# UNITED STATES PATENT AND TRADEMARK OFFICE

10/531,925

<b>Office Action Summary</b>	<b>Application No.</b> 10/531,925	<b>Applicant(s)</b> DINKEL ET AL.	
	<b>Examiner</b> ROCCO ITALIANO	<b>Art Unit</b> 3746

## **DETAILED ACTION**

Fig.2

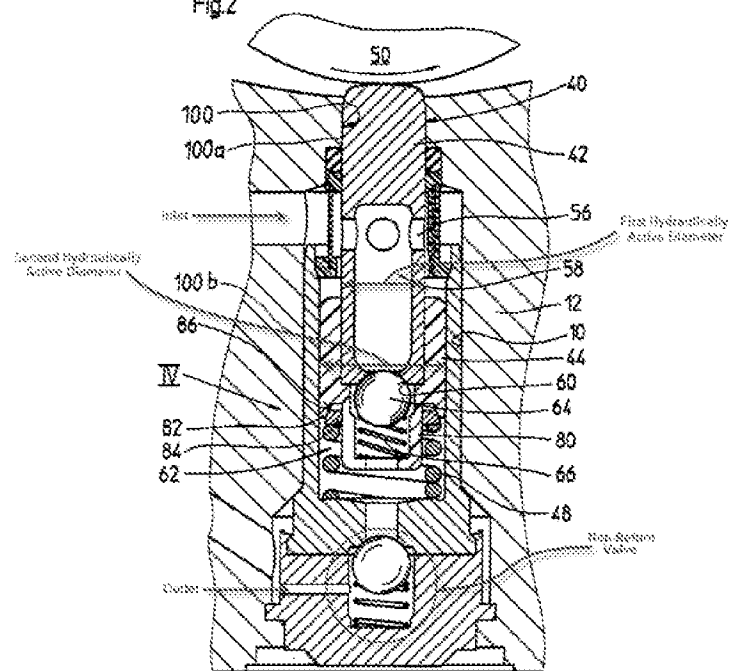
In regards to claim 11 Siegel et al. discloses: a piston pump, or supply device for a hydraulic brake system with a pressure fluid inlet and a pressure fluid outlet (see features labeled in Fig. 2 by the examiner for clarity); a piston (40) movably arranged in an accommodating member (12) and at least two hydraulically active diameters for supply in the direction of the pressure fluid outlet (see Fig. 2 labeled by the examiner for clarity); a non-return valve (26, 62) used for ventilating a working chamber (78) into which the piston (40) is immersed (see Fig. 1-2 and column 4, lines 55-60); a multi-part design piston (40) comprising at least two synchronously moveable partial pistons (42 and 44) wherein the first partial piston (42) exhibits a first hydraulically active diameter and a second partial piston (44) exhibiting a second hydraulically active diameter (see Fig. 2 labeled by the examiner for clarity).

In regards to the claim limitation set forth by the applicant wherein the piston “has a multi-part design” the applicant gives no clear indication that the piston is formed from an arrangement of separable parts or individual elements. Therefore in examining by means of the broadest reasonable interpretation, the examiner notes that the prior art according to Siegel et al. does disclose an equivalent piston (40) comprising of multiple parts (42, 44) or “a multi-part design” as indicated by the applicant.

With respect to claim 12 and 13, it can be seen in Fig. 2 according to Siegel et al. that the first partial piston (42) is configured in an analogous manner to that of the applicant allowing for the first partial piston (42) to be provided as a rolling bearing needle. Furthermore, it is disclosed by Siegel et al. that the second partial piston (44) is made of plastic (see column 1, line 19-35 and column 4, lines 24-28). In regards to the claims reciting that the second partial piston is formed from plastic through the process of molding, it is considered by the examiner as a product by process and therefore does not distinguish itself as patentably distinct over the prior art.

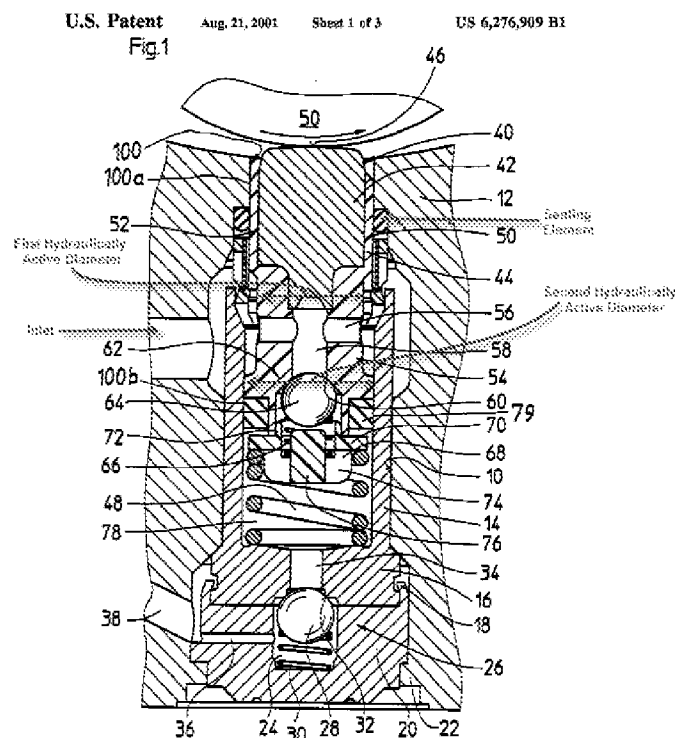
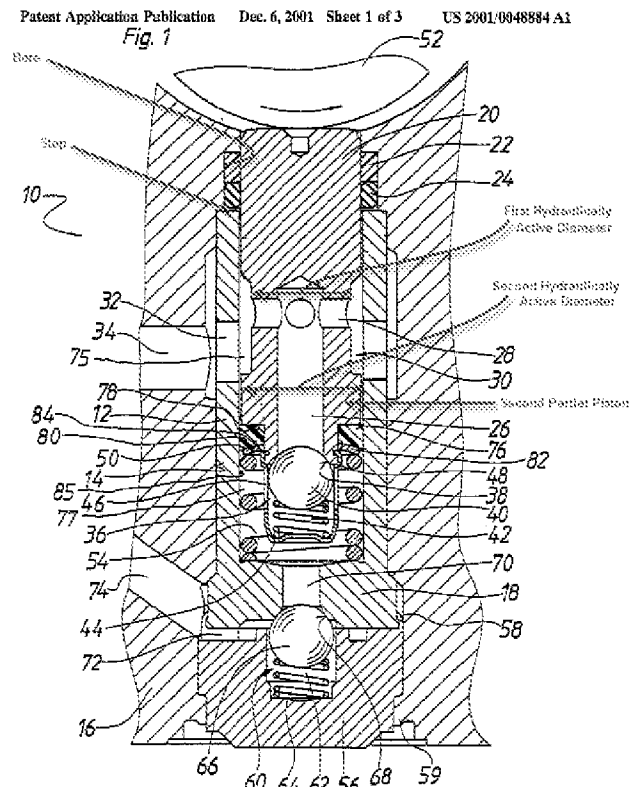
In regards to claim 14 Siegel et al. discloses: a piston pump, or supply device as indicated by the applicant, for a hydraulic brake system with a pressure fluid inlet and a pressure fluid outlet (36) (see Fig. 1 labeled by the examiner for clarity); a piston (40) movably arranged in an accommodating member (12) and at least two hydraulically

active diameters for supply in the direction of the pressure fluid outlet (36) (see Fig. 1 labeled by the examiner for clarity); a non-return valve (62) used for ventilating a working chamber (78) into which the piston is immersed wherein a first partial piston (42) and a second partial piston (54) are arranged and guided so as to be movable guided in the accommodating member (12) (see Fig. 1 and column 3, line 26-35).

With respect to claim 15 Siegel et al. discloses a sealing element (79) associated with the first partial piston (42) and a sealing element (feature labeled by the examiner in Fig. 1) associated with the second partial piston (54). It can be visually seen in Fig. 1 that both sealing elements are utilized for sealing the working chamber (78) (see Fig. 1 provided above).

In regards to claim 16 Siegel et al. discloses a second partial piston (54) includes a sealing seat (60) for a valve member (64) of the non-return valve (62) (see Fig. 1).

With respect to claim 17 it can be seen in Fig. 1 according to Siegel et al. that the non-return valve (62) is arranged in a similar manner as described by the applicant whereby the non-return valve (62) is integrated into the second partial piston (54).

In regards to claim 18 the arrangement of the non-return valves according to Siegel et al. are analogous to the non-return valves provided by the applicant. Siegel et al. Discloses non-return valve (62) configured as a suction valve and an additional non-return valve (26) designed as a pressure valve having a sealing seat (32) provided at a base member (16) that includes a casing (14) in which the second partial piston (54) is received (see Fig. 1).

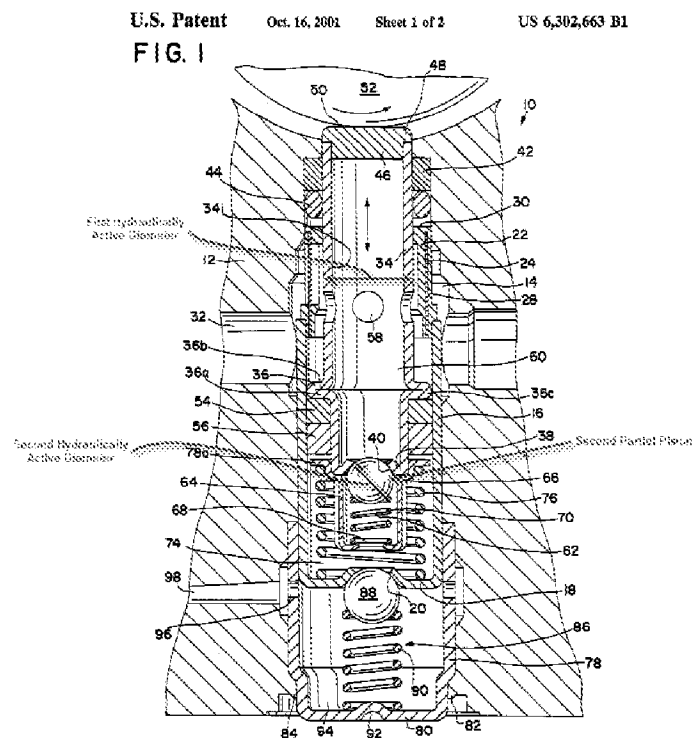
In regards to claim 20 Schuller et al. discloses: a piston pump for a hydraulic vehicle brake system (10), or supply device for the supply of pressure fluid into at least one vehicle brake as claimed by the applicant, with a pressure fluid inlet (32) and a pressure fluid outlet (98); a piston (34) is movably arranged in an accommodating member (12) and has at least two hydraulically active diameters for supply in the direction of the pressure fluid outlet (98) (see Fig. 1 labeled by the examiner for clarity);

at least one non-return valve (86) for ventilating the working chamber (74) into which the piston is immersed; a second partial piston designed as a ball wherein the ball is arranged and guided in a casing (16) of a base member (18) for a non-return valve (86) (see Fig. 1 labeled by the examiner for clarity provided below).

In regards to claim 20, the non-return valve (86) is designed as an integral sleeve-type non return valve.
